ESTUDIOS SOBRE LA OPERACION Y SEGURIDAD DEL SISTEMA DE EMBALSES DE VALDESIA

SECOND TECHNICAL REPORT ^{1/}

INSPECTION, MAINTENANCE AND SAFETY STUDIES

OPERATIONAL AND SAFETY STUDIES OF THE VALDESIA RESERVOIR

FIGURE 4.8. SEDIMENT DEPOSITION IN VALDESIA

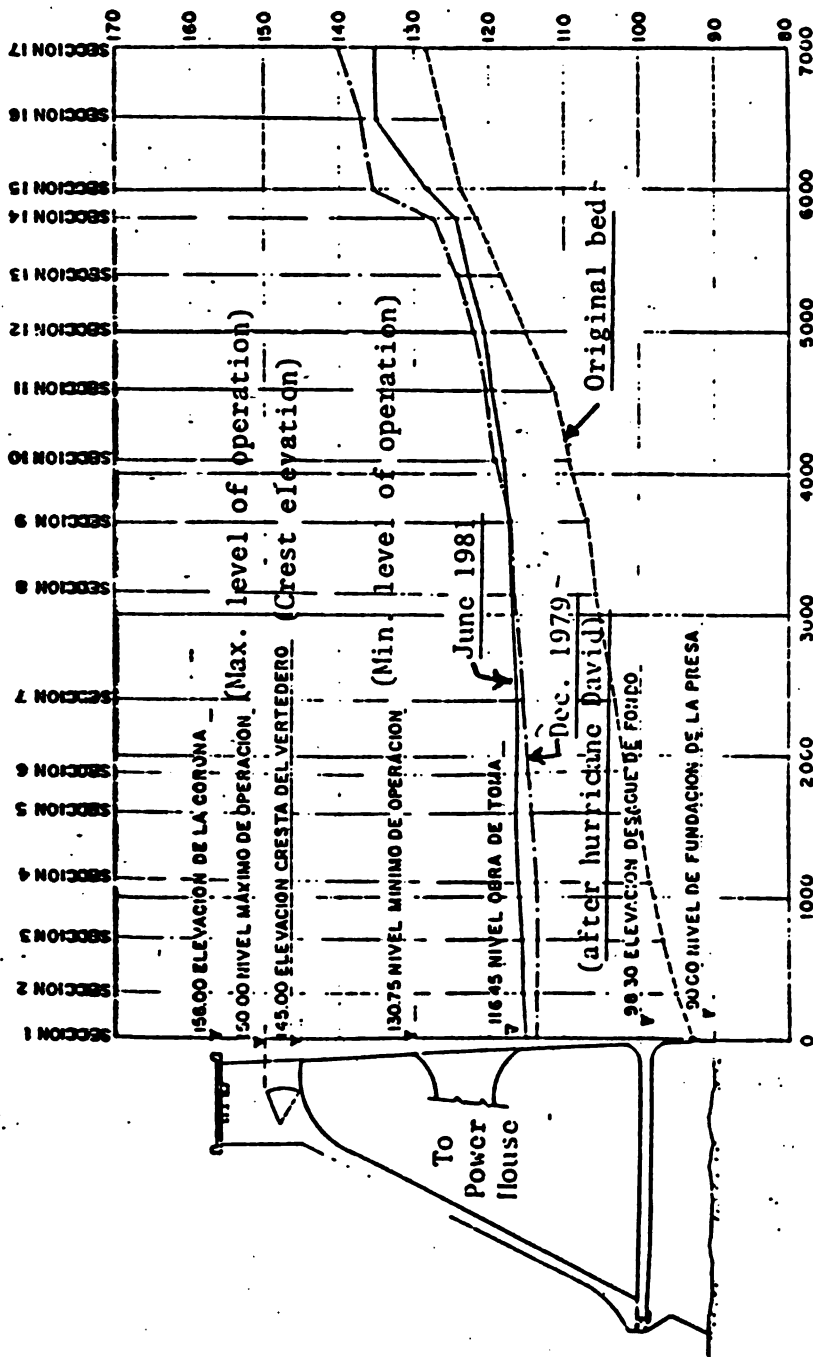
(2) A great deal of sediment deposition occurred in Valdesia Reservoir after Hurricane David. Figure 4.8 indicates the sediment deposit level in Reservoir Valdesia. This top sediment deposit level is rather close to the power intake. The excavation of these sediment deposits in this reservoir will begin soon.

5. Sediment deposits at Valdesia should be monitored carefully and removed when necessary to insure that coarse sands and gravels do not pass through the low-level outlets and power intake.

Figure 4.9 - Por Pressure Distribution for Block 5 - 1982

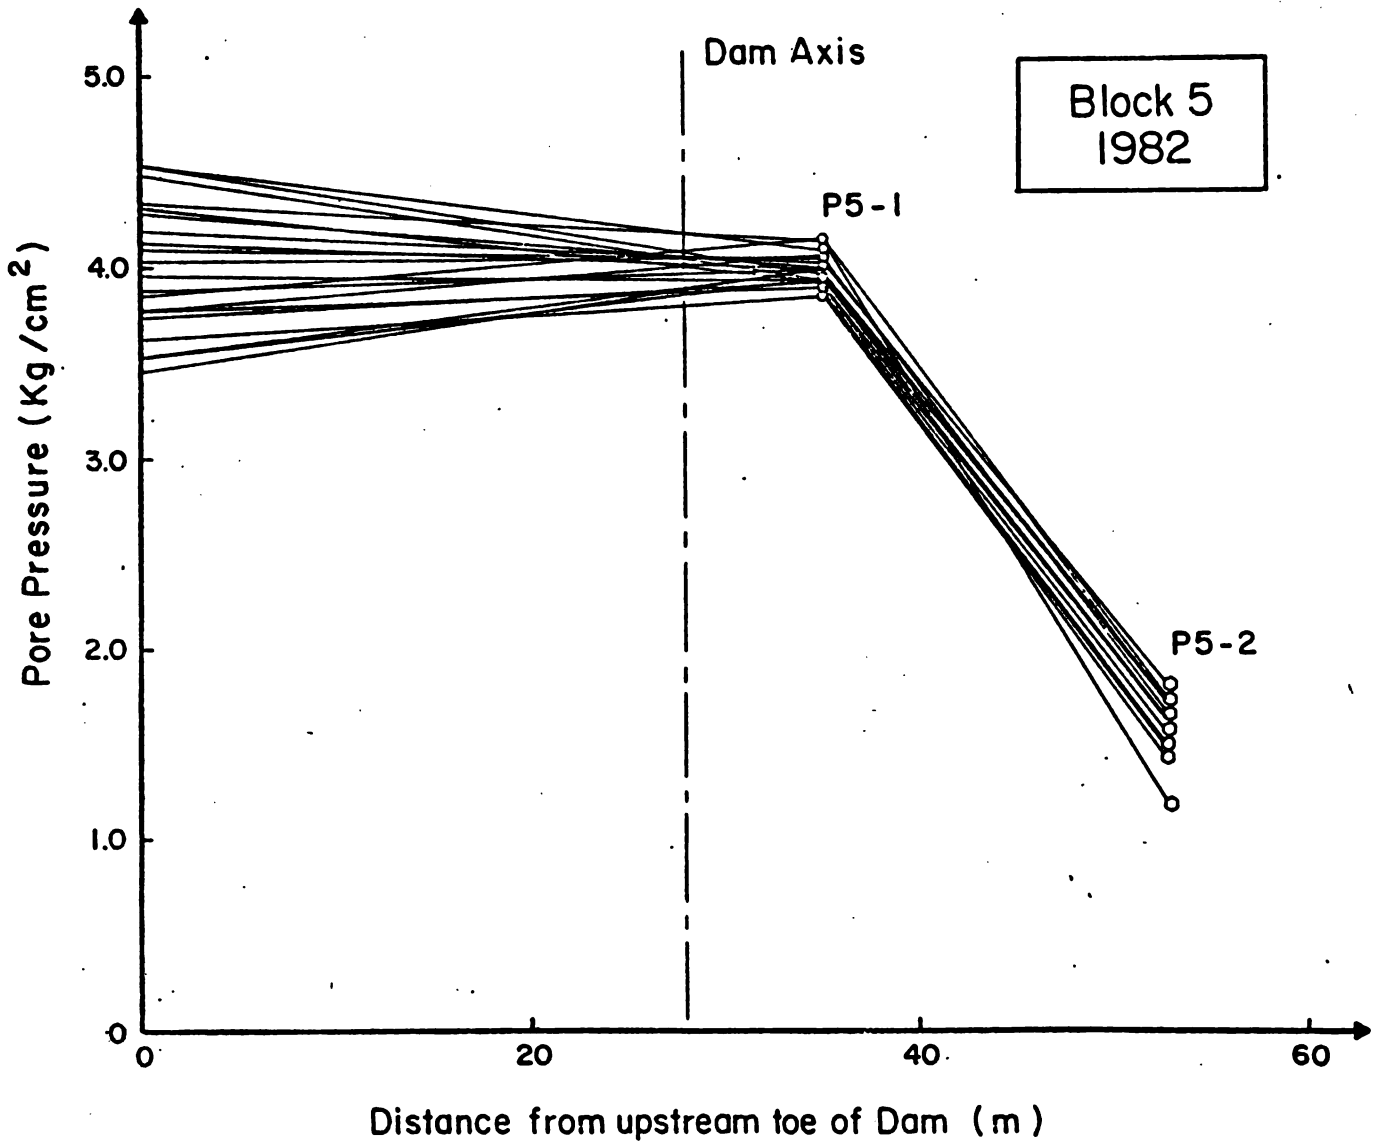
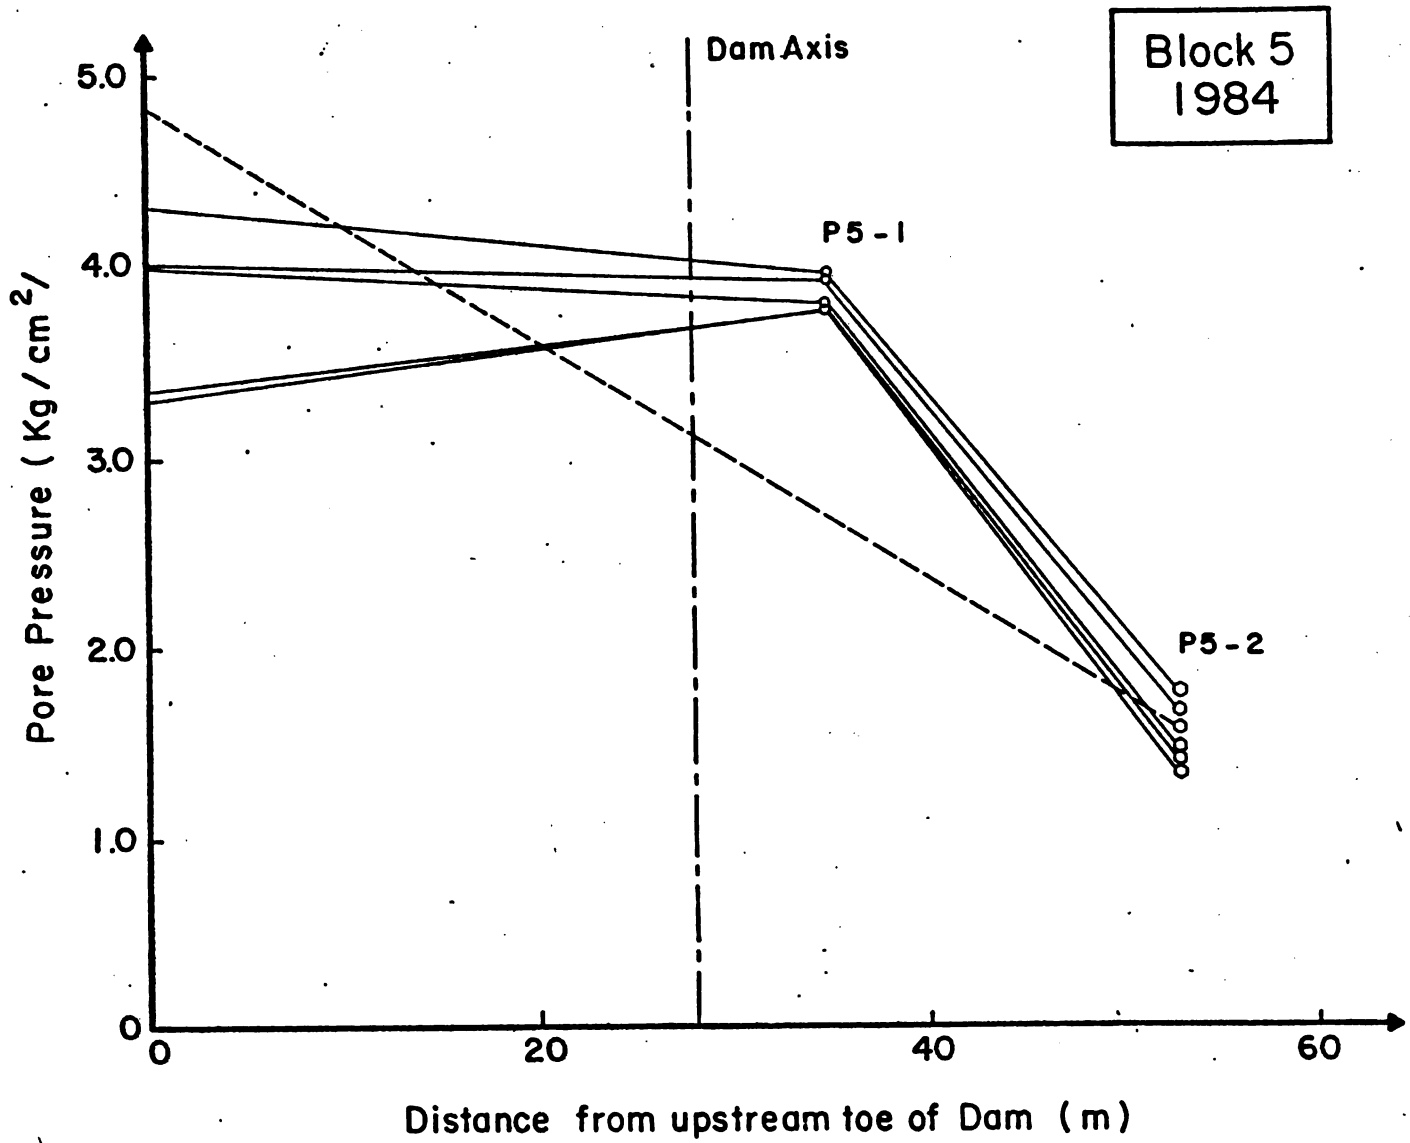
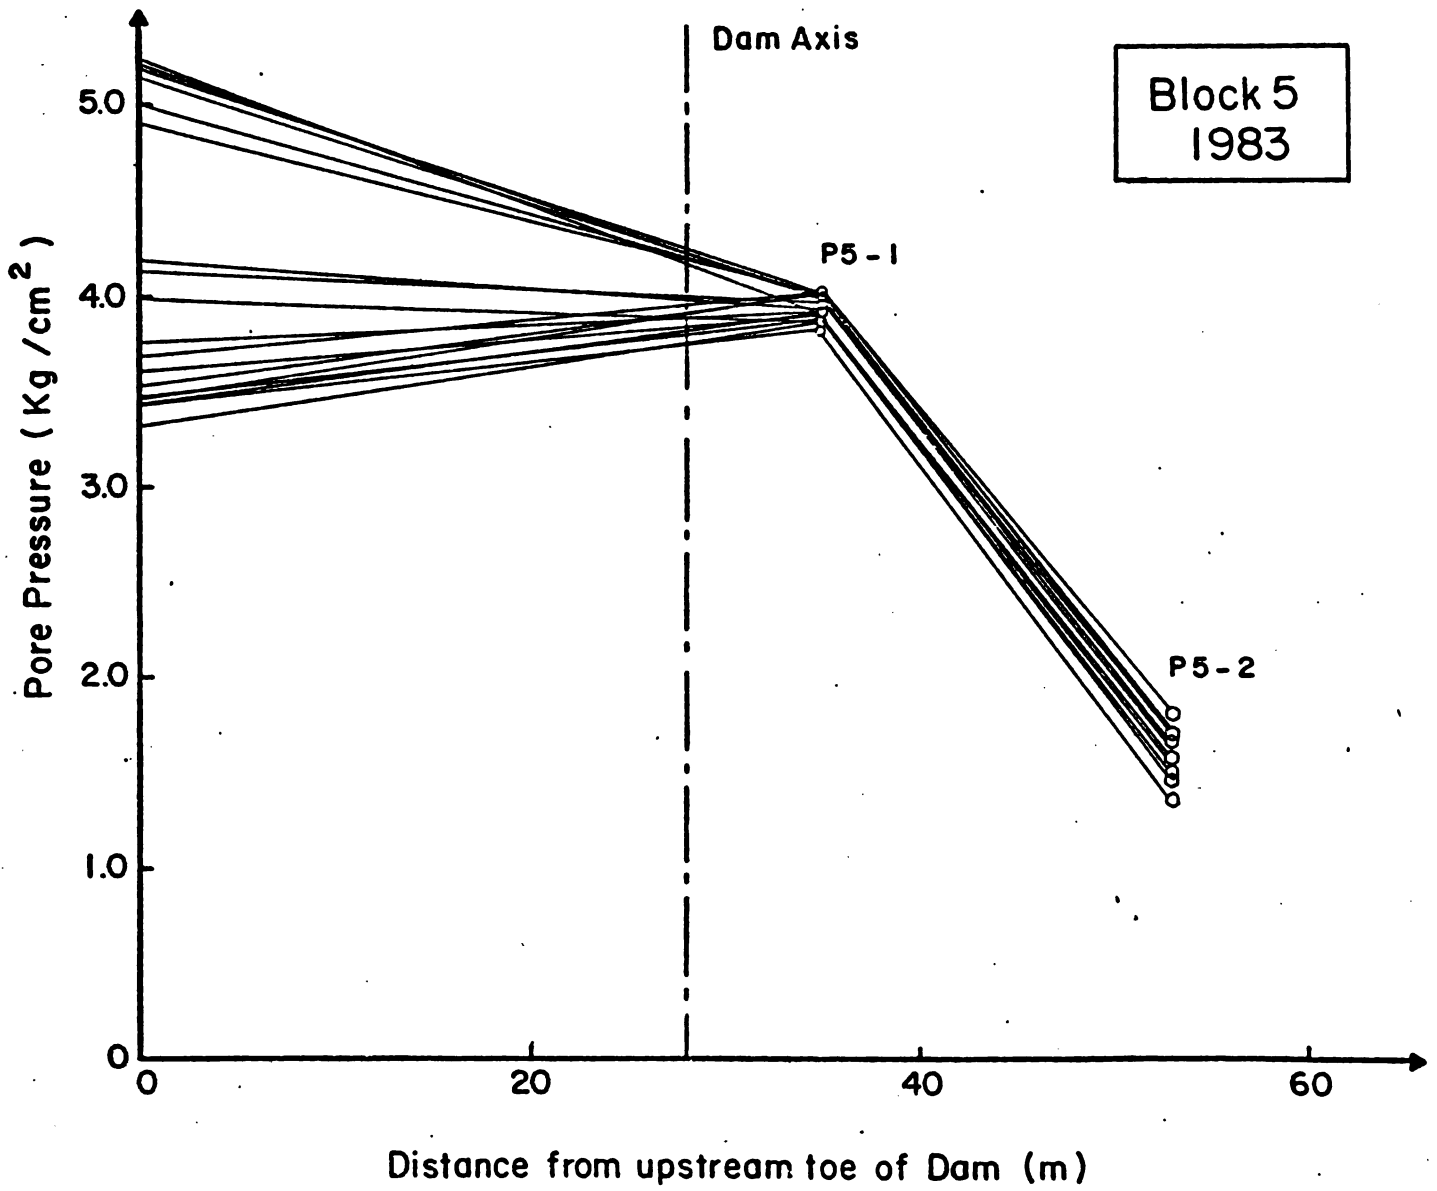
Block 5 is certainly dangerous, and uplift pressure underneath Block 17 is rather marginal. Detailed stability analysis to investigate the overturning of dam must be conducted at once. Figures 4.21 and 4.22 are for pore pressure distributions of piezometer P18-1.

As discussed in Section 4.5, piezometer P5-1 did not function properly. A check should immediately be made of the piezometric P5-1 to determine if the measurements being obtained are accurate. This can be accomplished by either installing an additional piezometer of another type close to any piezometer whose measurements are suspect or by temporarily converting a nearby drain hole to measure uplift pressures. The latter method can be accomplished by inserting a packer with gage into the top of the drain hole.

Figure 4.23 Direct pendulums transverse movement in 1982-1984.

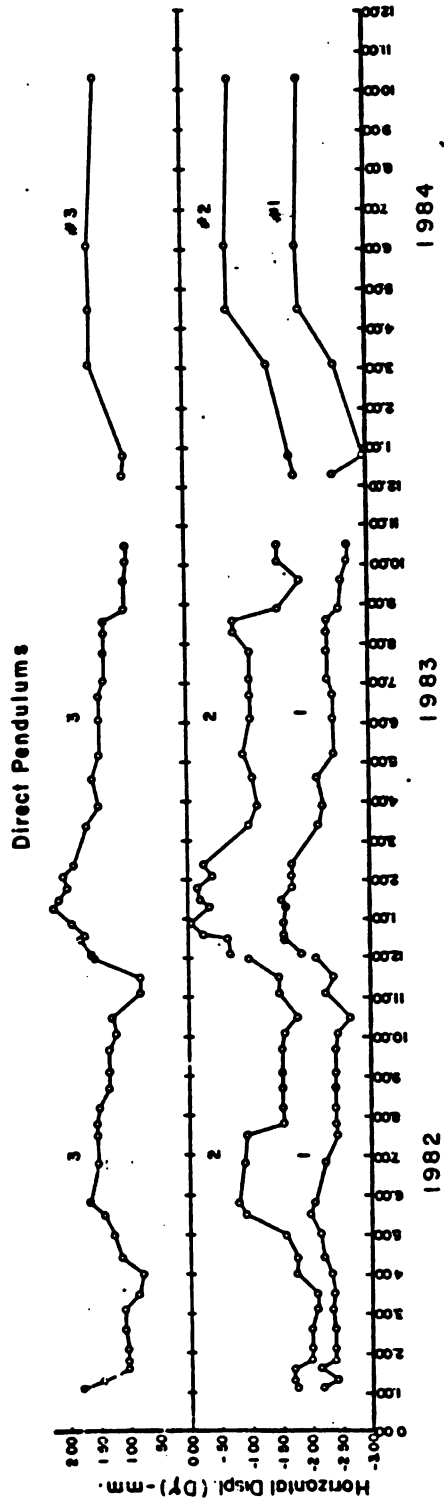
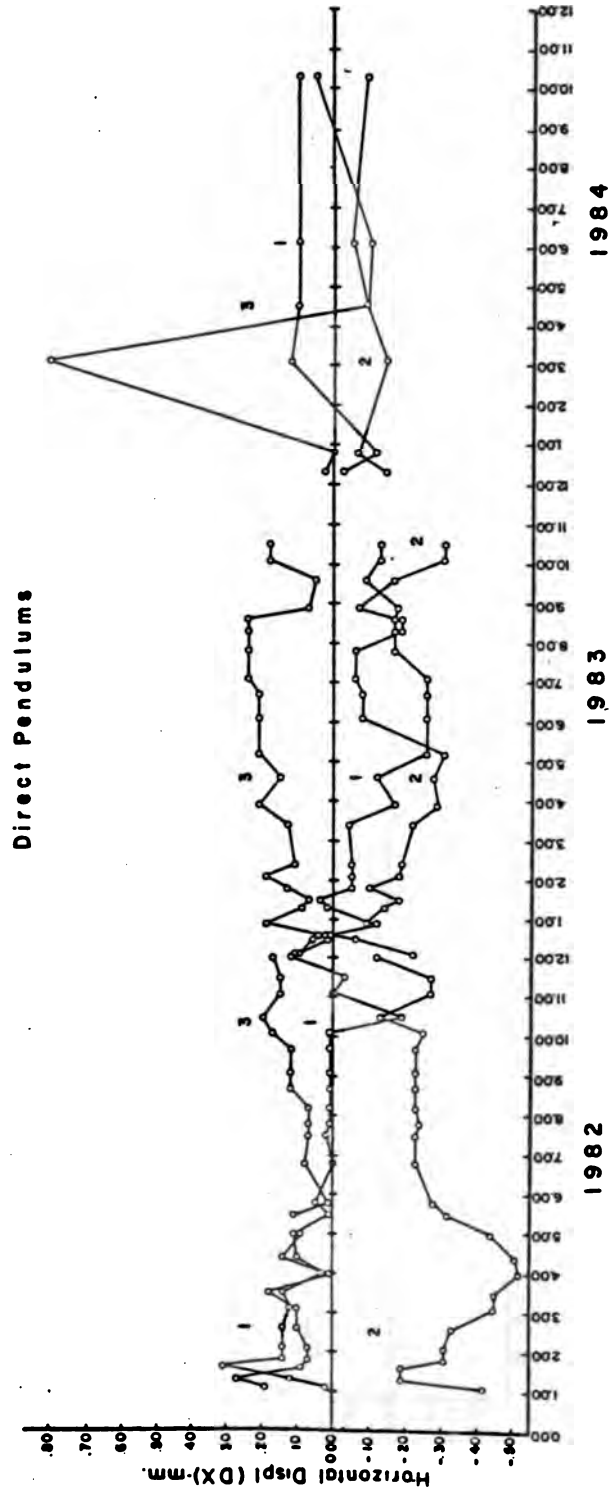
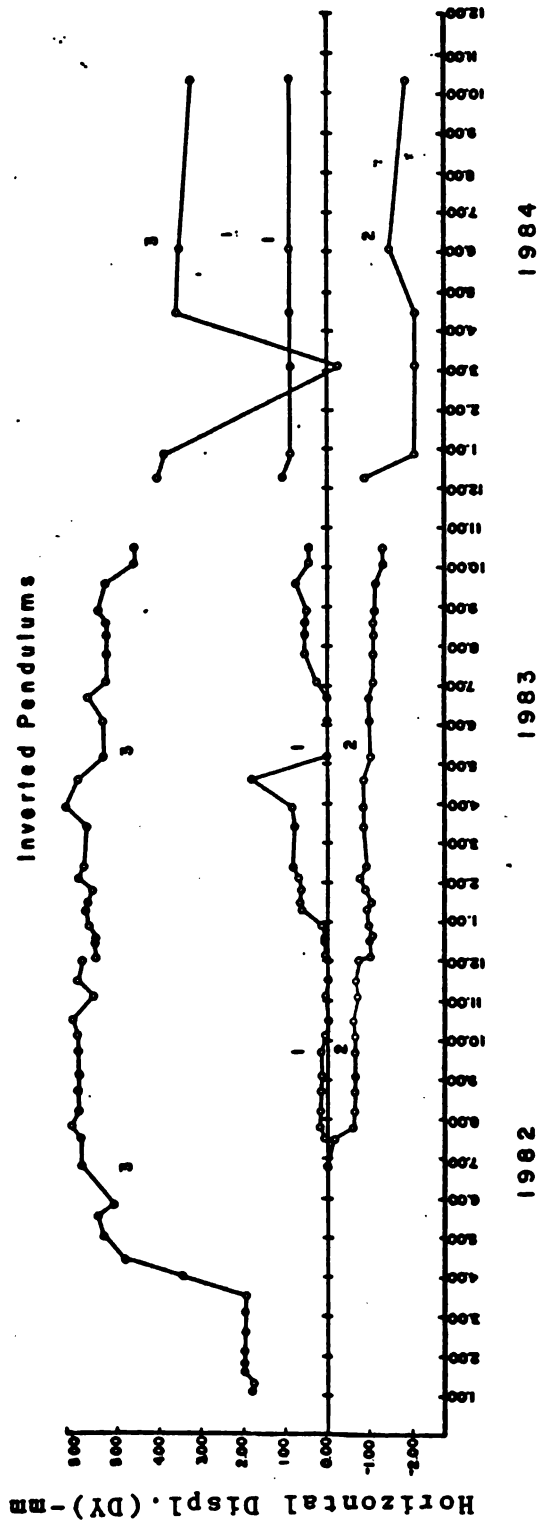
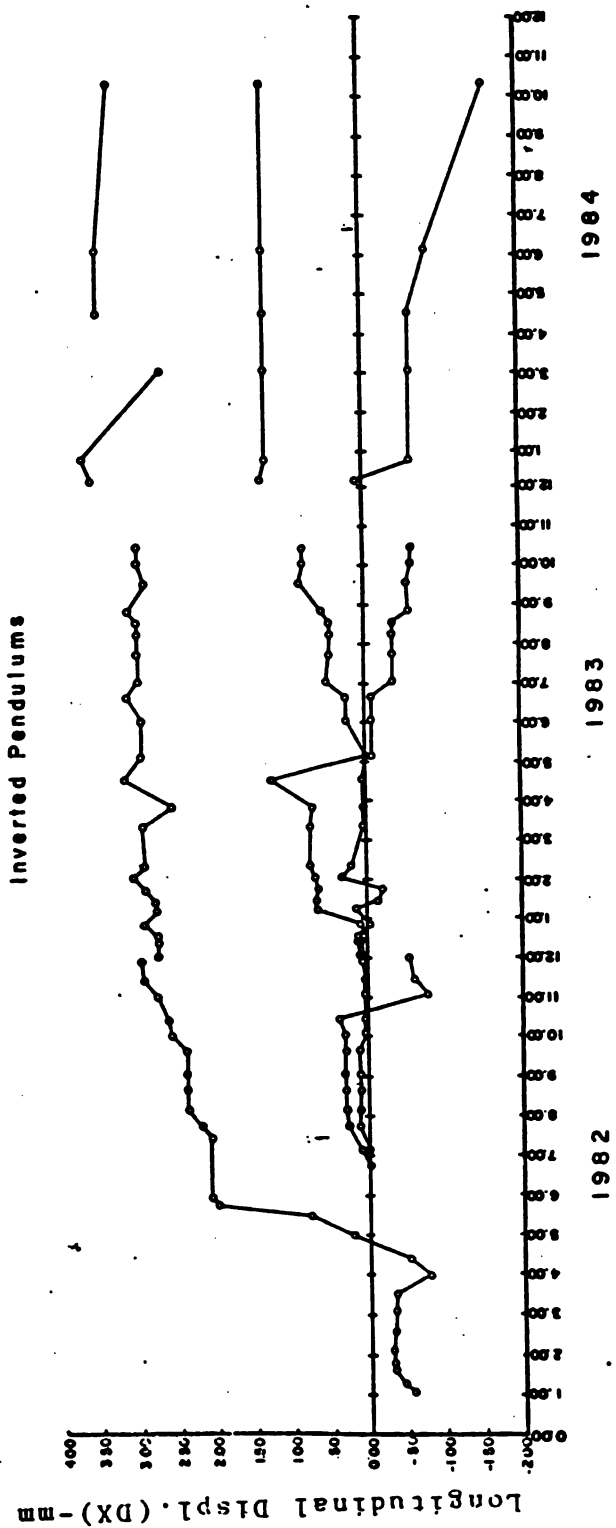
There are six pendulums installed inside the dam to measure the movements of the dam. As shown by Figures 4.24 and 4.25 for "direct pendulum", the maximum movements for each pendulum was less than 2 millimeters between 1982 and 1984 and also in 1984 the pendulum readings were very stable. The No. 1 and No. 2 inverted pendulum fluctuated within 2 millimeters between 1982 and 1984. However, No. 3 inverted pendulum, inserted at Buttress Block 15, had moved considerably (about 4 mm) between March to July 1982 both in transverse and longitudinal directions. Figures 4.26 and 4.27 show the pendulum wire movements. One must note that No. 3 direct pendulum is also inserted at Buttress Block 15 and had not moved considerably between March to July 1982. This discrepancy should be investigated at once. It appears that the dam movements could certainly be caused by thermal stresses due to temperature fluctuations. In the future, its pendulum should move more than 5 mm which was the maximum movement recorded in the past four years, one must employ a specialist to investigate this matter. Fluctuation of readings within narrow limits are certainly better than progressing movements in one direction.
